Addendum One

A
STEEL CABLE HANDRAIL DETAIL
SCALE: 1/2"=1'-0"

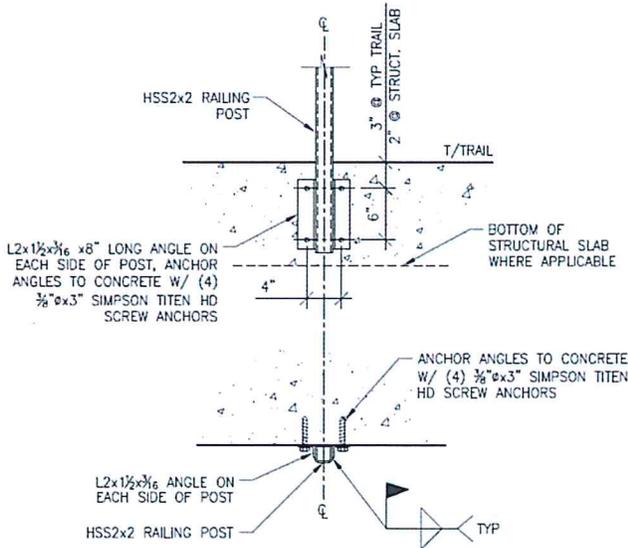
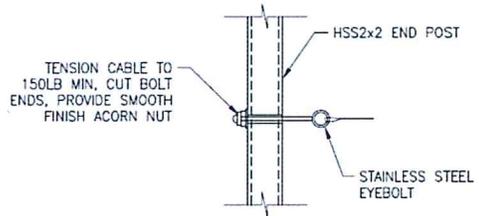
6. Can you provide a detail for item "METAL POST CABLE RAIL, AT STRUCTURAL SLAB (Designed by Structural Engineer)"?

Please see attached metal post and cable detail. Detail provided is for basis of design only.
